ADDENDUM # 4

Project	TA Blakelock High School Renovations	Project No.	2215-C
Location	1160 Rebecca Street, Oakville, ON	Date of Issue	2025 05 02
Owner	Halton District School Board	File	2215/7.1.3

This Addendum forms part of the Contract Documents and amends the original Drawings and Specifications, dated 2025 04 17, and all preceding Addenda, as noted below.

Drawing Title:
LIBRARY WASHROOMS
FLOOR PLAN, RCP AND
INTERIOR ELEVATIONS

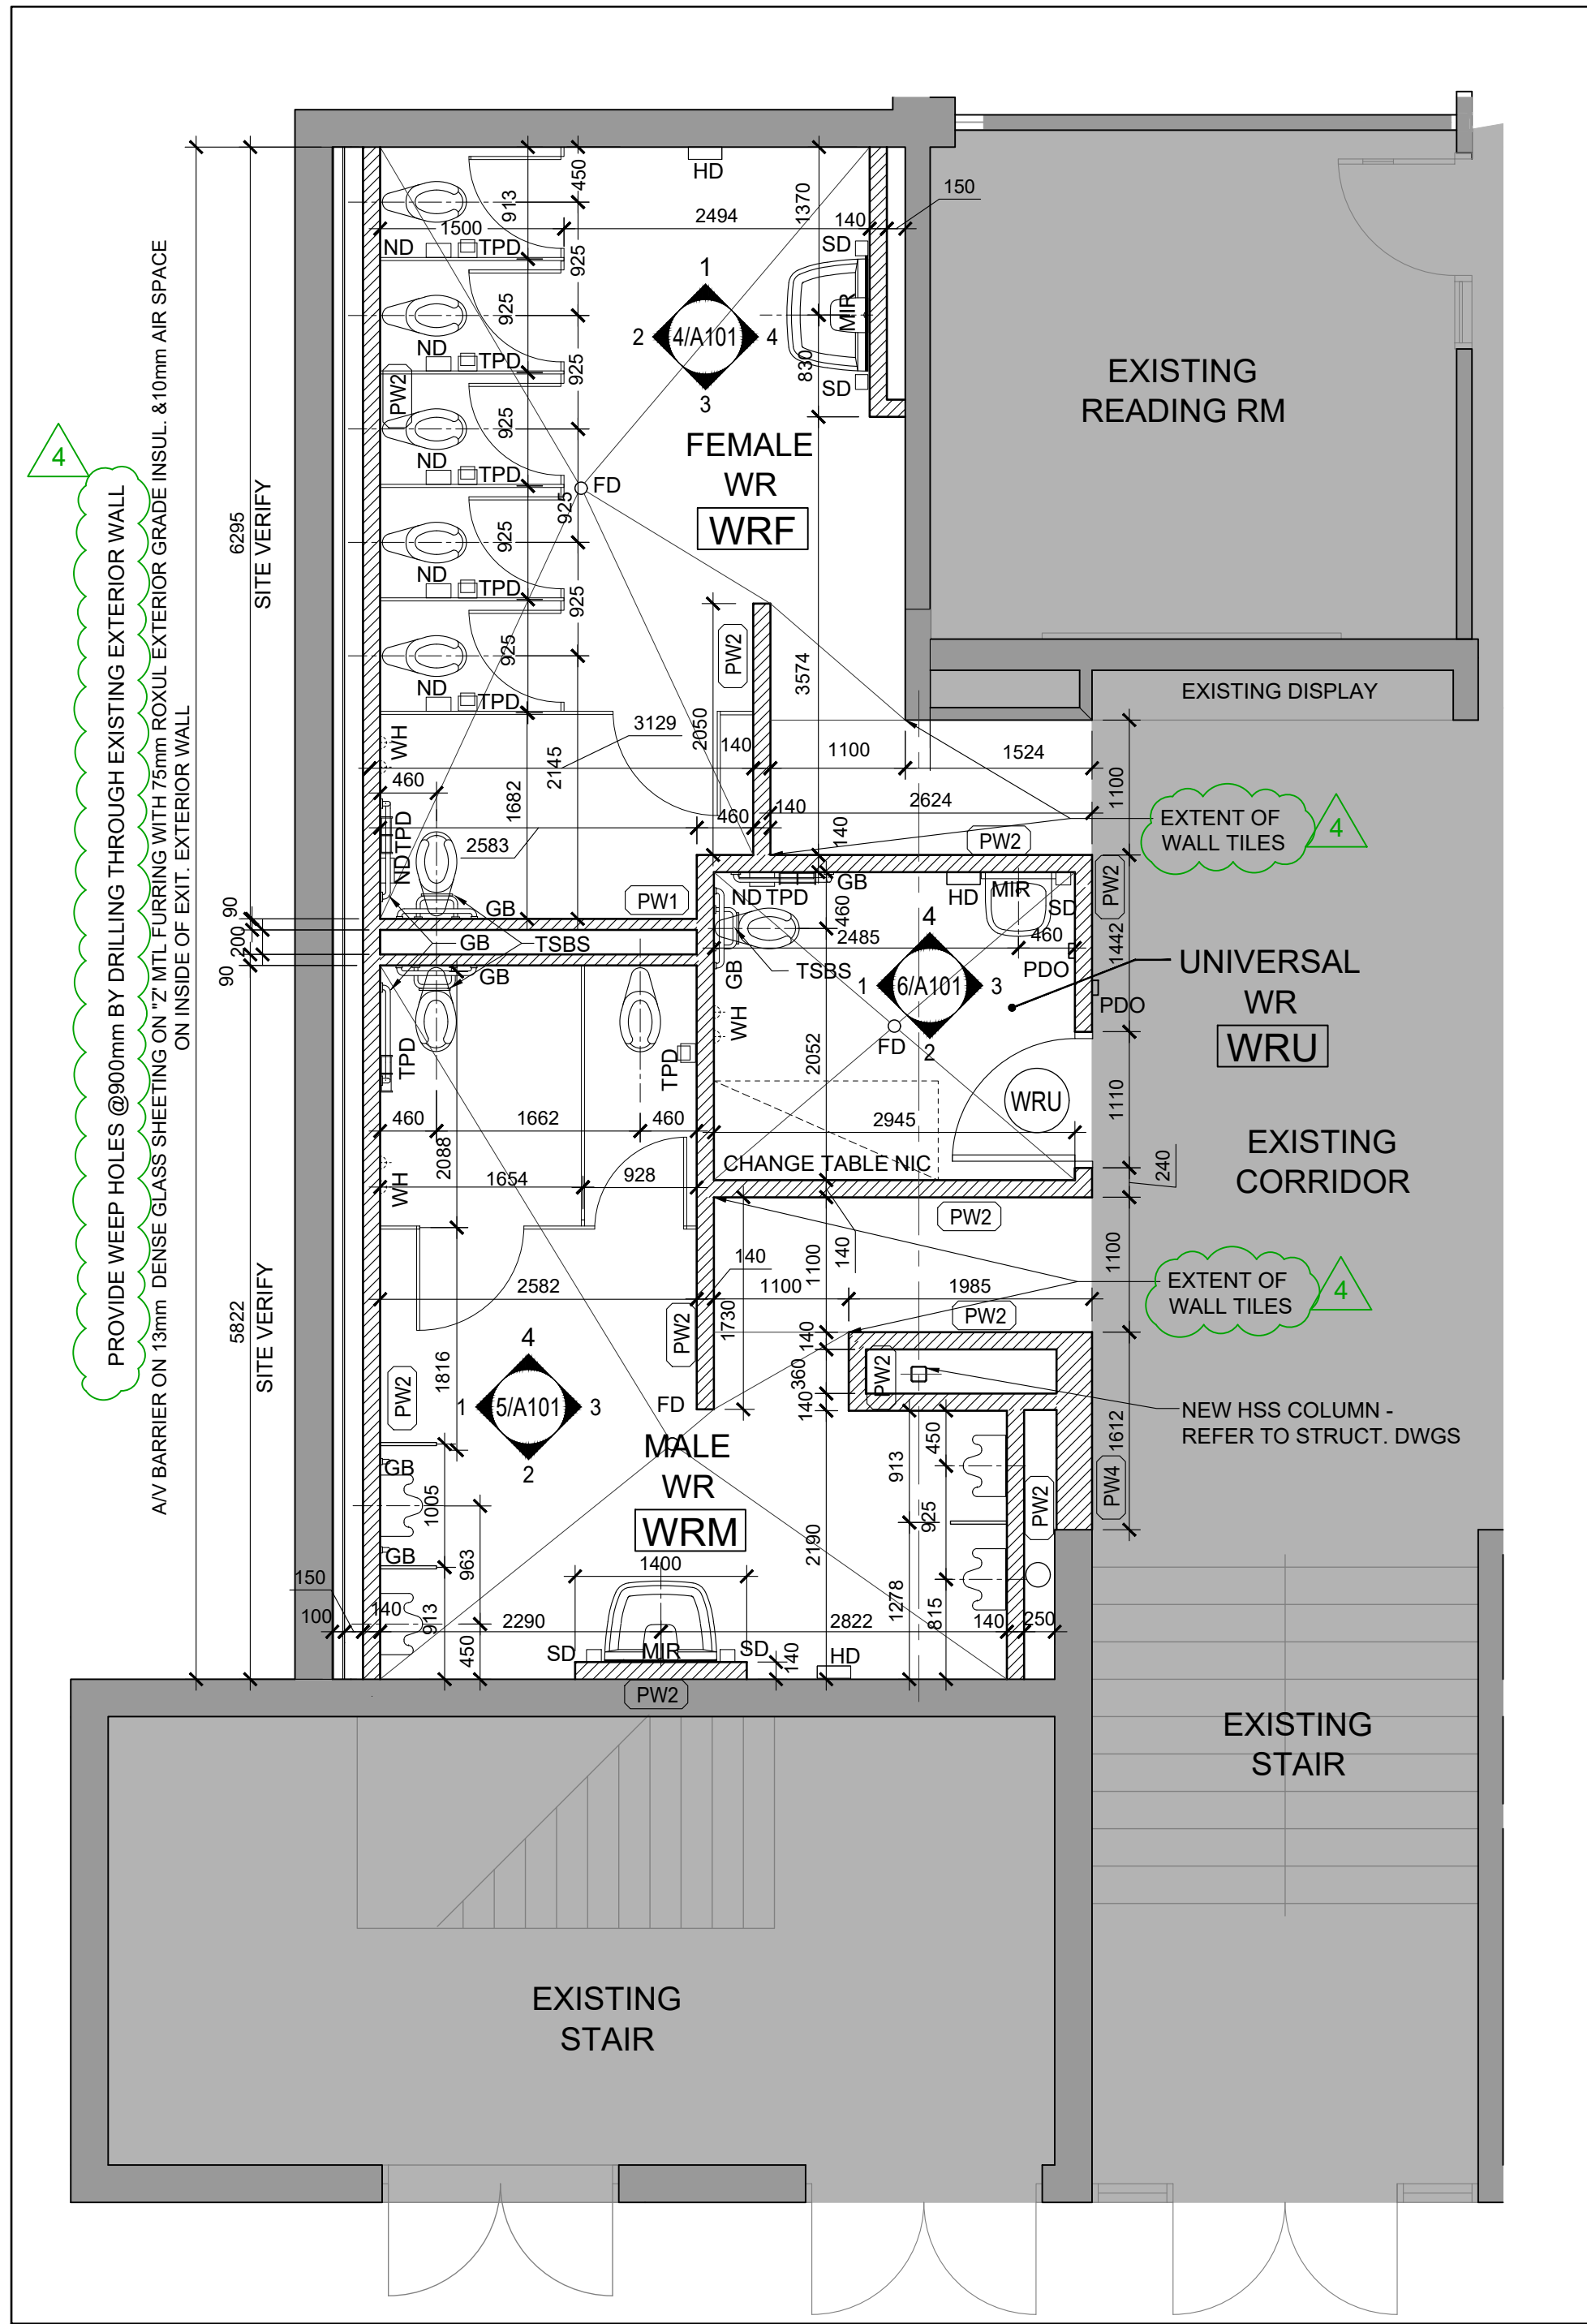
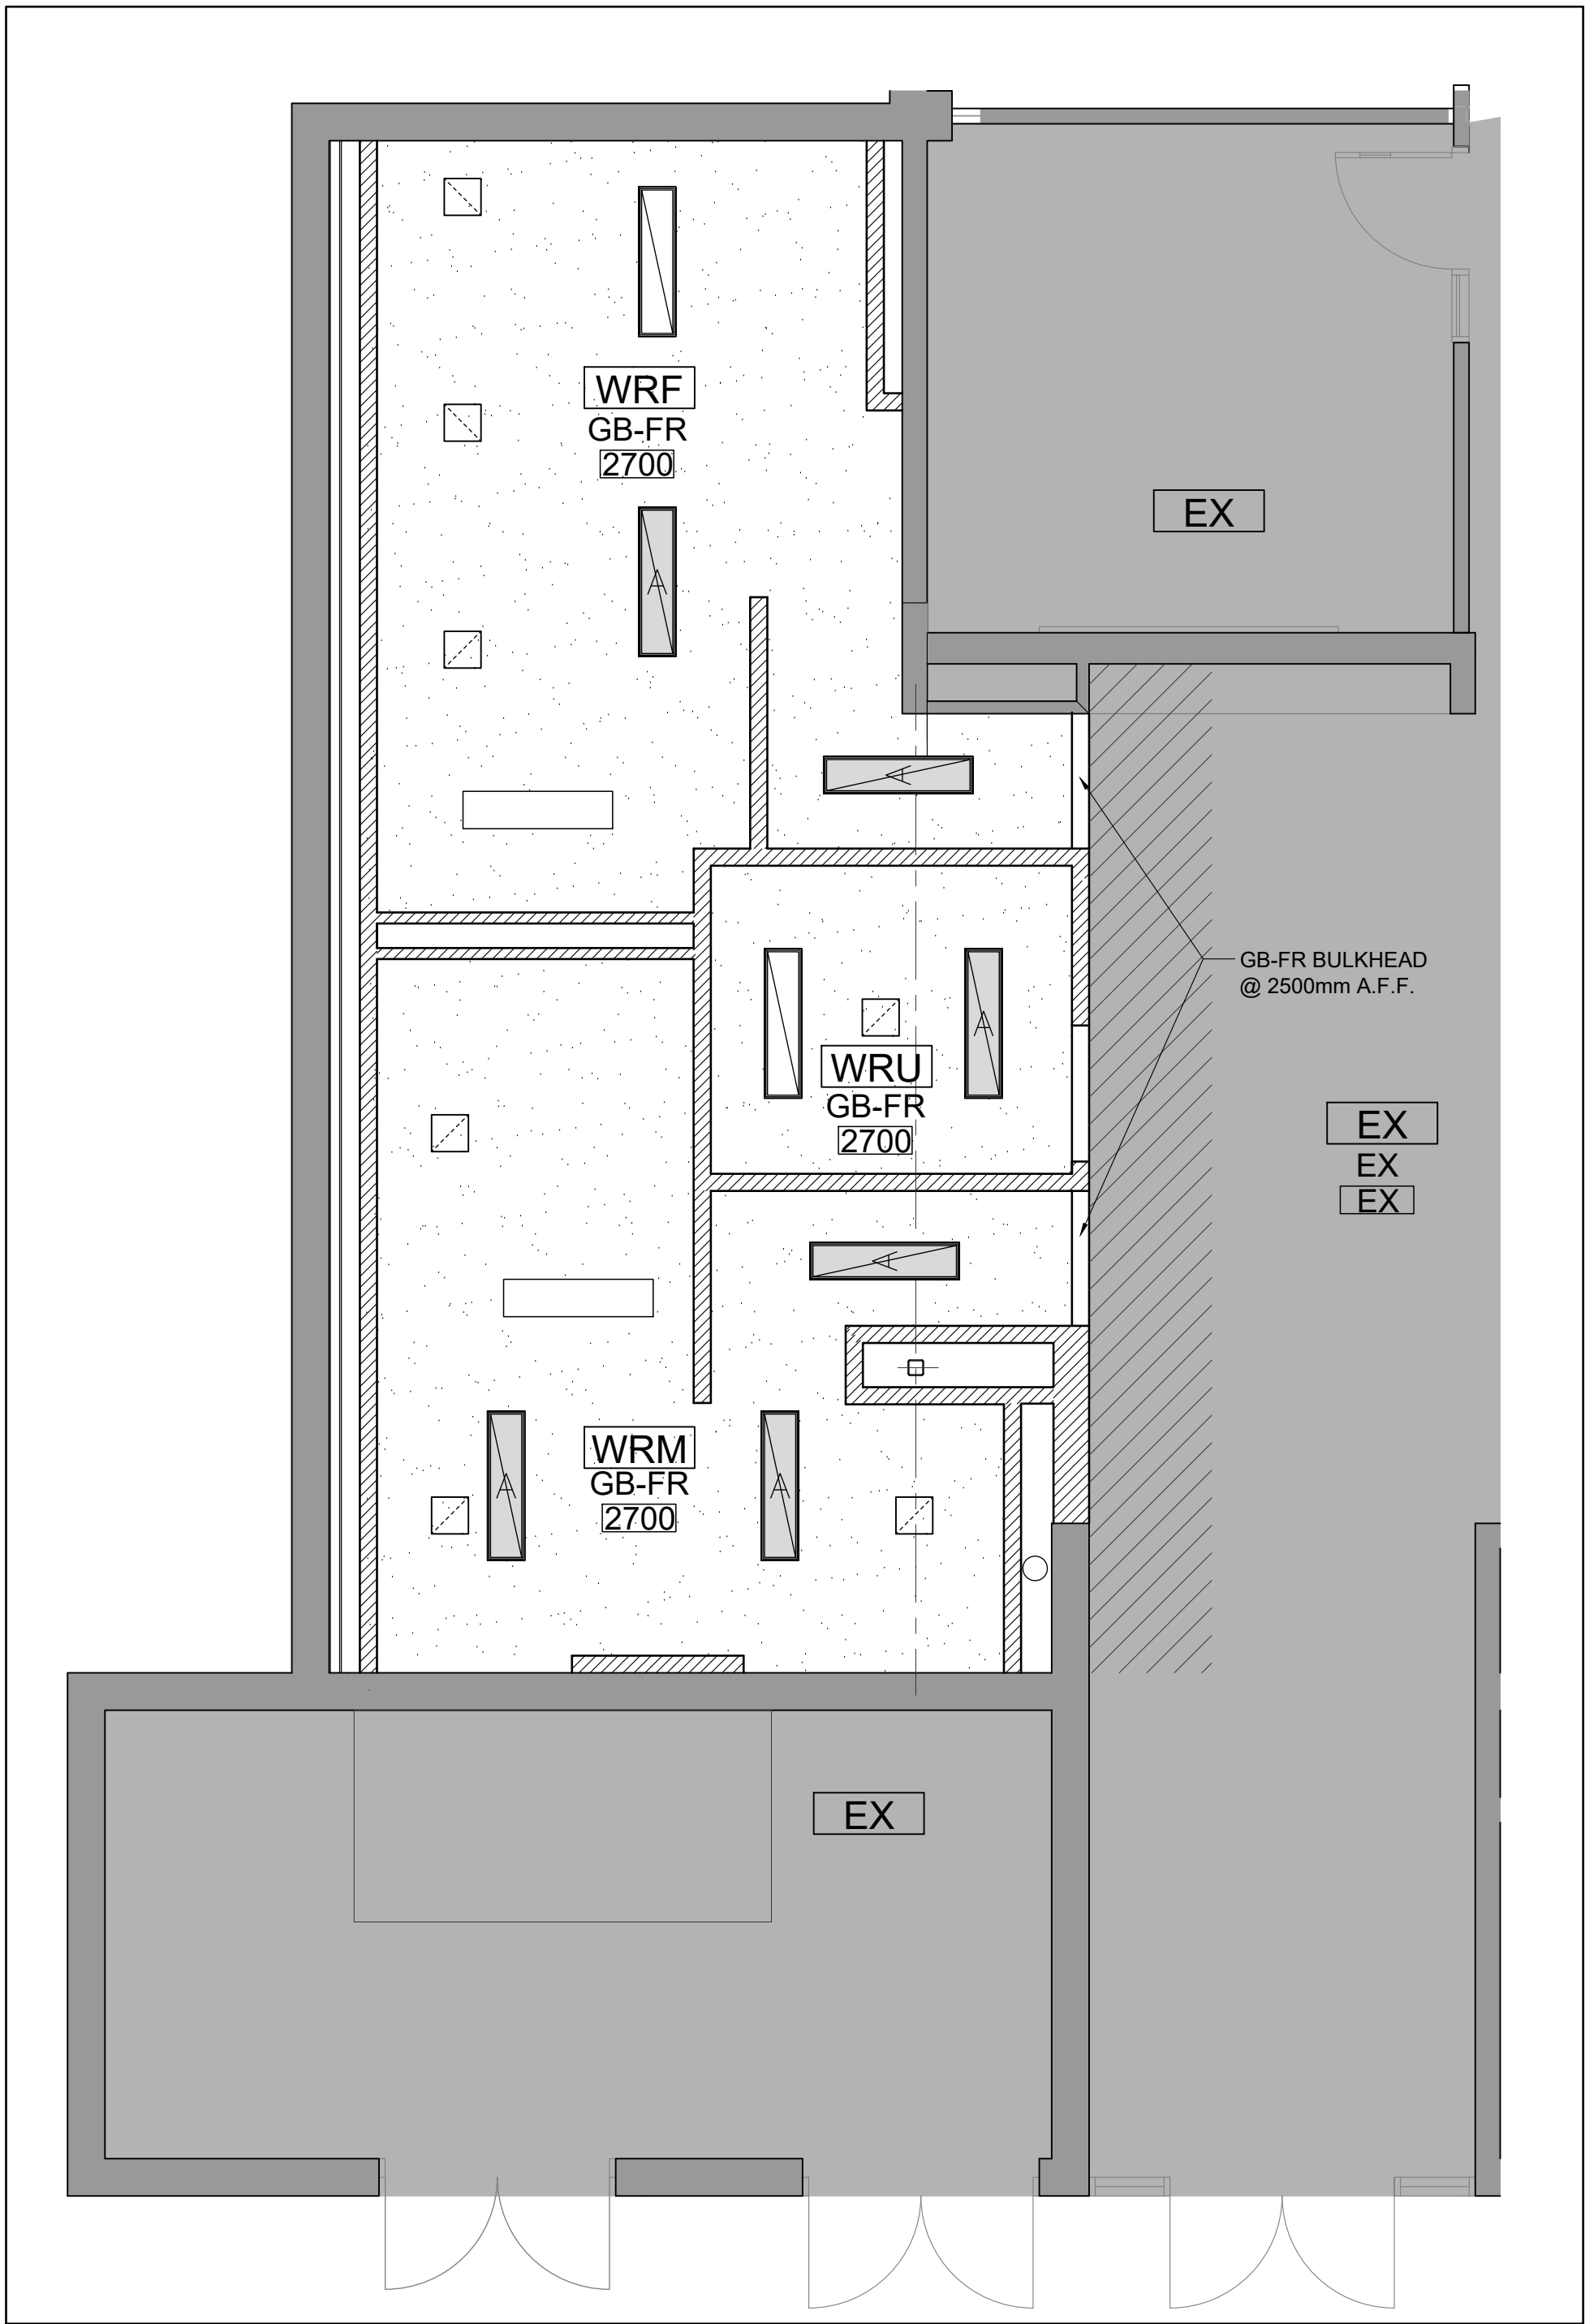
- .1 Re-issued drawing with additional notes
